RESOLUTION NO. 2005-077

RESOLUTION AMENDING THE NATOMAS EASTSIDE PLANNED UNIT DEVELOPMENT GUIDELINES AND SCHEMATIC PLAN FOR PROPERTY LOCATED IN SOUTH NATOMAS, SOUTH OF WEST EL CAMINO AND WEST OF GATEWAY OAKS DRIVE, SACRAMENTO, CA.

(APN: 225-1010-006, -007, and -019)
(P04-129)

EXHIBIT 1 – PUD Guideline Amendment

EXHIBIT 2 – PUD Schematic Plan Amendment

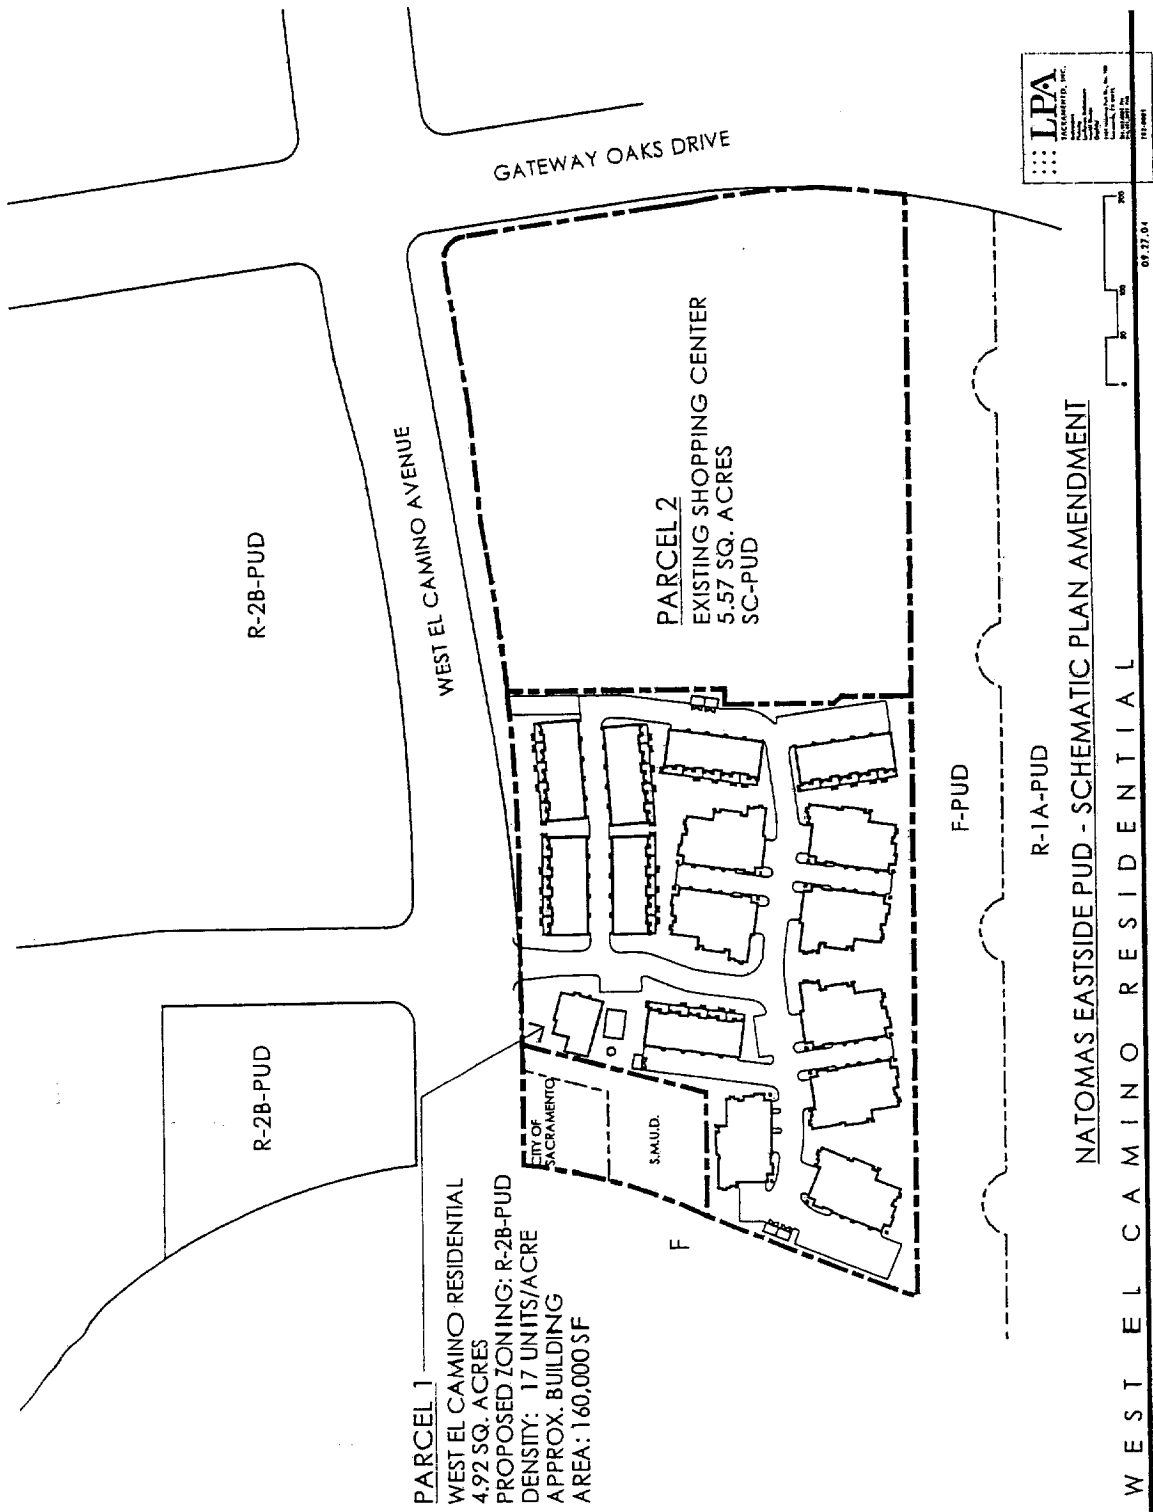
2. The Schematic Plan Amendment for the Natomas Eastside Planned Unit Development is established as attached hereto as Exhibit 2 with the following conditions:

- a. Map conditions shall supersede PUD guidelines.
- b. Site access to individual parcels will be determined as part of the Special Permit review process. Site access shall be at the discretion of the Development Engineering and Finance Division.
- c. All proposed PUD elements within public right-of-way (Street Cross-Sections, Landscaping, etc.) shall be to City Standards and at the discretion of the Development Engineering and Finance Division.
